Interactive comment on “Development and characterization of a High-Temperature Proton-Transfer-Reaction Mass Spectrometer (HT-PTR-MS)” by T. Mikoviny et al.

T. Mikoviny et al.

Fig. 1.

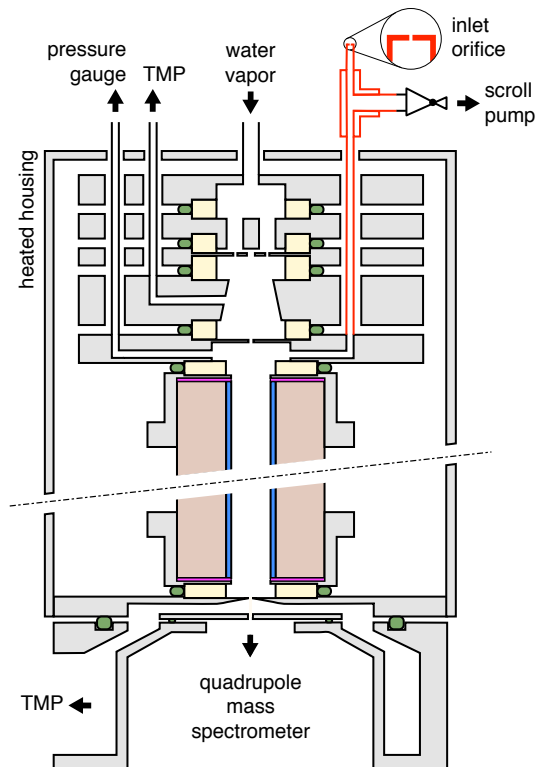
Page 189 - description of the new hollow cathode (HC) ion source design. Traditional HC ion sources have a water flow exhaust line that is pumped. This new design seems to lack this feature. Is this an oversight in the schematic or can the HC source be operated without this pumped exhaust line? It is my understanding that the HC ion source must operate at a pressure lower than the drift tube. The authors need to comment on this change or adapt their schematic to show the presence of this exhaust line.

Page 189, line 10 - The authors state there are “three 0.5 mm diameter orifices which were aligned with the hollow cathode cylinders.” I guess I don’t understand this statement. I see that the drift tube is bound on either end by apertures and that there is another aperture at the entrance to the quadrupole mass spectrometer. Are the authors referring to these apertures? If so, I ask that the authors expand their discussion to more clearly identify the location of the three apertures being referred to.

Figure 1 - It seems that there should be a valve or second aperture in front of the scroll pump on the inlet line, otherwise the drift tube pressure would be reduced to the backing pressure of the scroll pump.

The reviewer is correct. We had overlooked this detail. The schematic has been adapted.

To clarify the details, we have expanded our discussion and have also adapted our schematics (Fig. 1). “The exit anode lens had one central orifice of 0.8 mm diameter and three 0.5 mm diameter orifices which were aligned with the cathode hollow cylinders. The three off-axis orifices had the primary function of reducing the pressure in the discharge region, thus improving the discharge stability.”

The schematic has been adapted to include this important detail.
